**Proposed Text for Section 5. thru 5.2.13.4,
Based on responses to Draft D1 Letter Ballot processed
at March 1995 Meeting**

Abstract: This paper presents the changes to section 5.1 thru 5.2 in the Draft Standard P802.11/D1 as a result of the Response to Draft D1 Letter Ballot processed at the March 1995 Meeting as shown in the companion Documents P802.11-95/67, P802.11-95/68 and P802.11-95/69.
Not all Letter Ballot comments were processed at the March 1995 Meeting.

Action: Adopt the changes in this paper to replace the relevant portions of Section 5 of P802.11/D1

Figure 5-6: Exponential Increase of CW

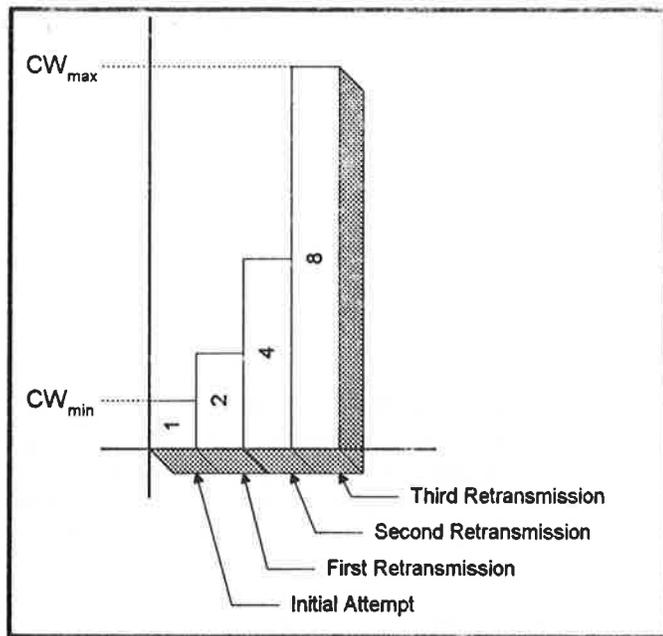
The numbers in this figure need to be changed into 31,63,127,255 respectively, which are given as an example.

Suggested values are for: $CW_{\min}=31$, $CW_{\max} = 255$.
